April 15, 2020

**Re: Request for Correction Under the Data Quality Act to NIST's Final Report on the Collapse of World Trade Center Building 7**

The information that is the subject of this Request is NIST's *Final Report on the Collapse of the World Trade Center Building 7* (NCSTAR 1A) and NIST's *Fire Response and Probable Collapse Sequence of World Trade Center Building 7* (NCSTAR 1-9), collectively referred to herein as the "NIST WTC 7 Report." Secondly, NIST's webpage titled *FAQs – NIST WTC 7 Investigation* (referred to herein as the "NIST WTC 7 FAQs") is also the subject of this Request. The NIST WTC 7 Report can be found at the following NIST webpage: <https://www.nist.gov/el/final-reports-nist-world-trade-center-disaster-investigation> (last visited April 14, 2020). The NIST WTC 7 FAQs can be found at the following NIST webpage: <https://www.nist.gov/topics/disaster-failure-studies/faqs-nist-wtc-7-investigation> (last visited April 14, 2020).

Figure 4.7 Columns 79, 80, and 81 are removed from Floor 45 to the penthouse. Tilting of the building is now negligible. The penthouse now collapses, as demonstrated from the significant amount of deflection given in the figure.

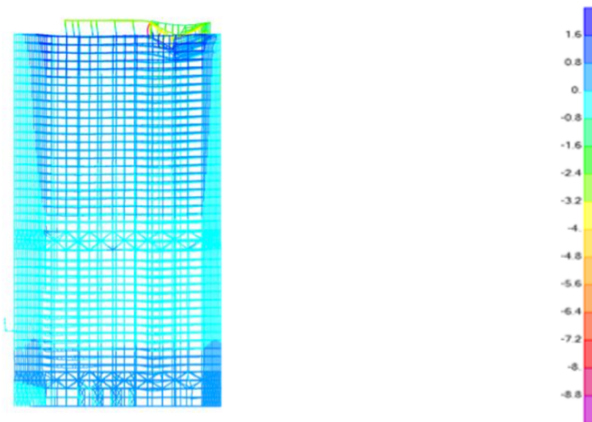
Second, the UAF team found that the failure of Columns 79, 80, and 81 would not have initiated an east-to-west progression of core column failures, as claimed by NIST (see the latter stages of NIST’s Probable Collapse Sequence on page 23 above). Therefore, the UAF team considered the possibility that the local failures that caused the global collapse were not actually a result of the earlier local failures that caused the collapse of the east penthouse. Thus, the UAF team simulated the simultaneous failure of all core columns over 8 stories followed 1.3 seconds later by the simultaneous failure of all exterior columns over 8 stories. The UAF team found that “the simultaneous failure of all core columns followed by the simultaneous failure of all exterior columns produces almost exactly the behavior observed in videos of the collapse.” (See UAF Report, p. 106.) Figure 4.17 of the UAF Report shows the UAF team’s global collapse analysis from two separate angles alongside corresponding video of the collapse.

Figure 11: The last frame of the UAF global collapse analysis overlaid on the first frame.

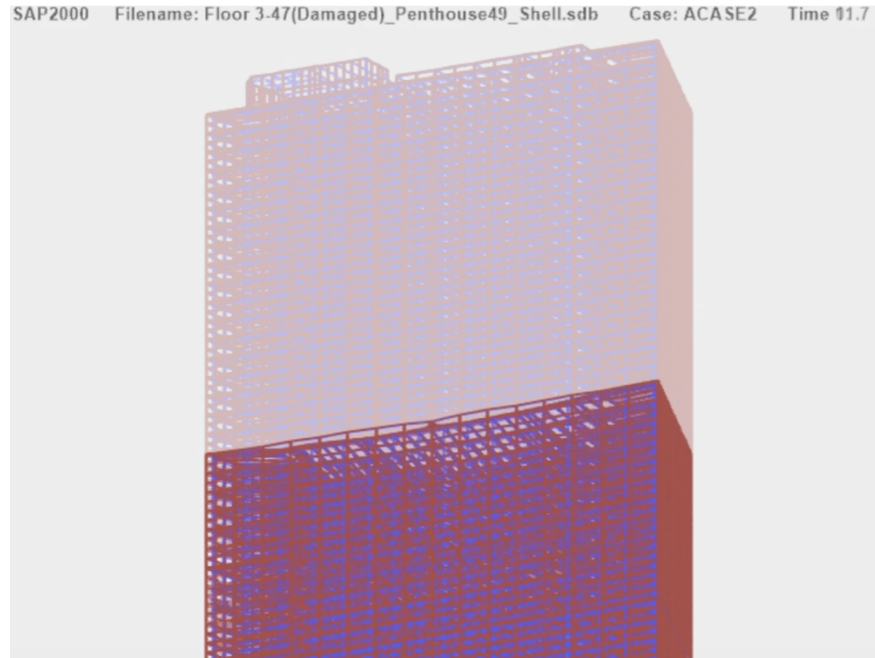
Figure 11 below illustrates how the collapse progressed in the UAF global collapse analysis by overlaying the last frame of the animation on the first frame the animation. As is apparent, the UAF global collapse analysis predicts minimal deformation of the exterior and a clean vertical descent, as observed in videos of the collapse.

Figure 4.20 Velocity comparison between Chandler measurement (green plotted line) and UAF simulation (red plotted line). Bold green trend line illustrates free fall.

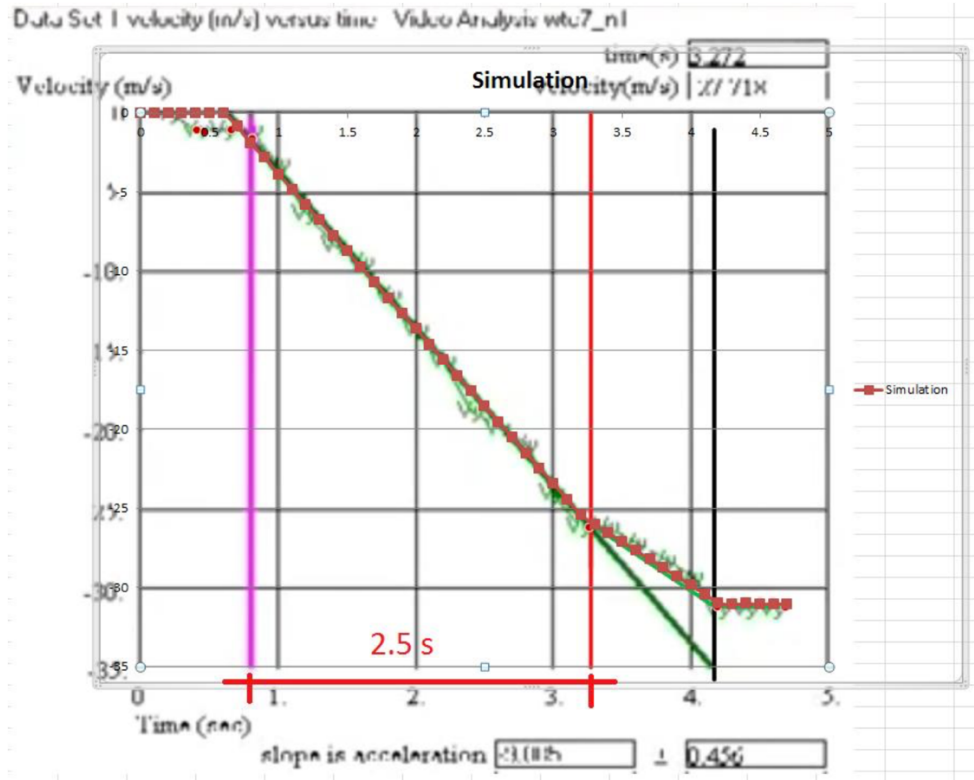
The UAF team also found that the simultaneous failure of all core columns over 8 stories followed 1.3 seconds later by the simultaneous failure of all exterior columns over 8 stories resulted in a downward velocity and acceleration that matched almost exactly with the observed 2.5 seconds of free fall, as illustrated below in Figure 4.20 from the UAF Report.

Figure 12: LDEO seismogram shows .6 Hz to 5 Hz waves. “PAL” refers to Palisades. In “EHE,” E: short periods, H: high gain, and E: east-west component. Rousseau cites this seismogram in his analysis. The NIST WTC 7 Report includes a different set of broadband seismograms.

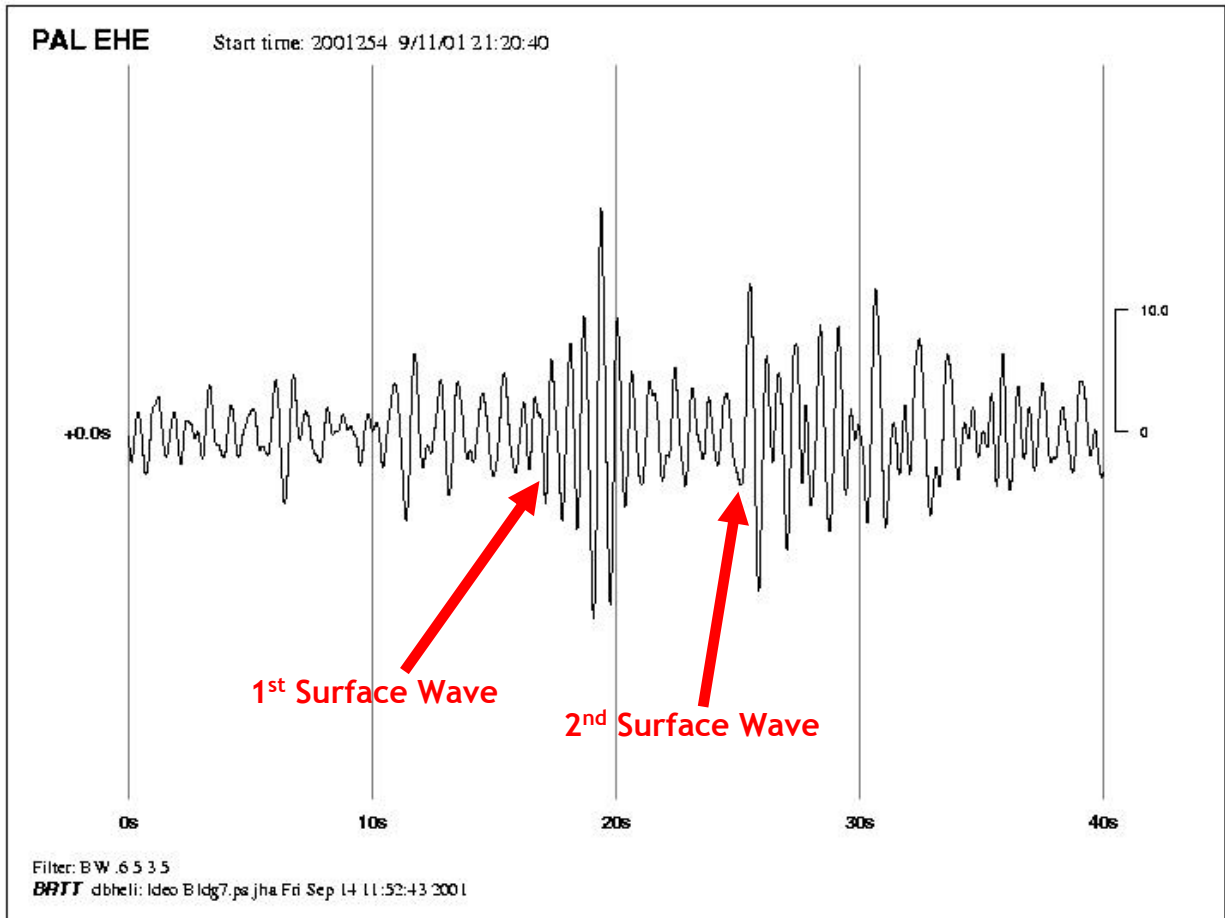
The recording of Rayleigh waves in the LDEO seismogram [shown below] unaccompanied by a pressure (P) wave and a shear (S) wave indicates the occurrence of subaerial explosions taking place close to the ground, where the emitted energy splits into sound waves, mostly in the air, and surface waves in the

around 100 Hz.” Furthermore, Rousseau attests, “the bell-like form in the LDEO seismogram points to an impulsive source of energy, not percussion on the ground due to the fall of debris.”

- a) **Revise the NIST WTC 7 Report to Reflect that Subaerial Explosions, as Opposed to the Alleged Cascade of Floor Failures and the Initiation of Global Collapse, Were the Actual Source of the Seismic Signals Generated During the Collapse of WTC 7**

First, NIST must revise the NIST WTC 7 Report to reflect that subaerial explosions, as opposed to the alleged cascade of floor failures and the initiation of global collapse, were the actual source of the seismic signals generated during the collapse of WTC 7.
